Subject: Programmatic Environmental Impact Statement for Alternative Strategies for the Long-Term Management and Use of Depleted Uranium Hexafluoride. Summary, DOE/EIS-0269, December 1997.

*Comments on the Draft Programmatic Environmental Impact Statement (PEIS) for
Alternative Strategies for the Long-Term Management and Use of Depleted Uranium
Hexafluoride*

Depleted UF6 Draft PEIS, December, 1997, Vol. 1 - Page 3-7

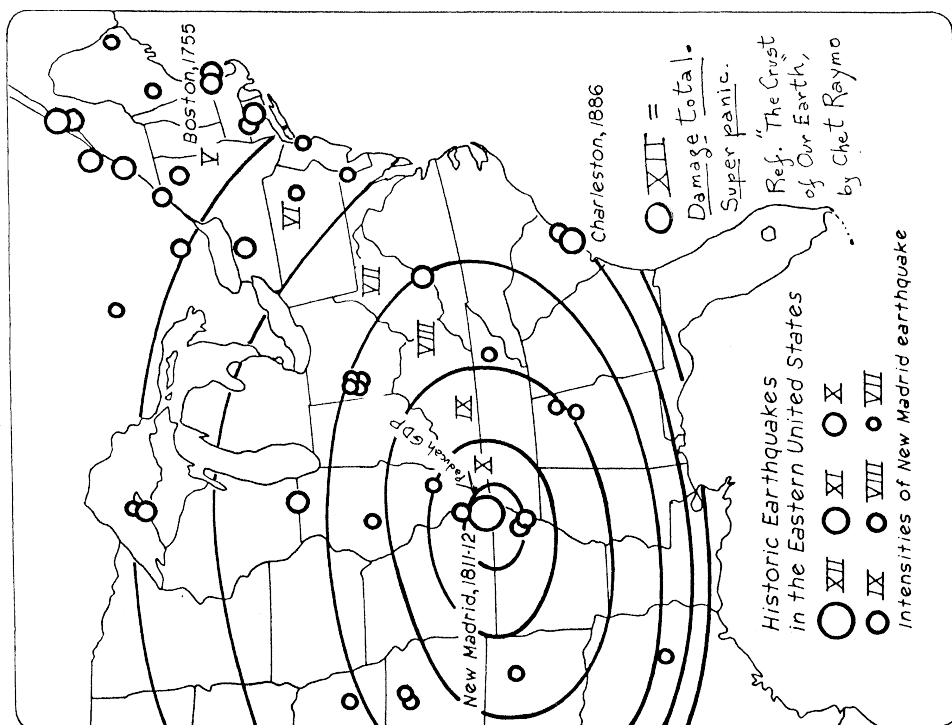
3. The draft PEIS presents brief and totally inaccurate statements regarding the New Madrid earthquake safety issue, which is of particular importance to the Paducah plant site which has in excess of 28,000 of the DUF₆ cylinders. (PEIS reference - page 3 -7)
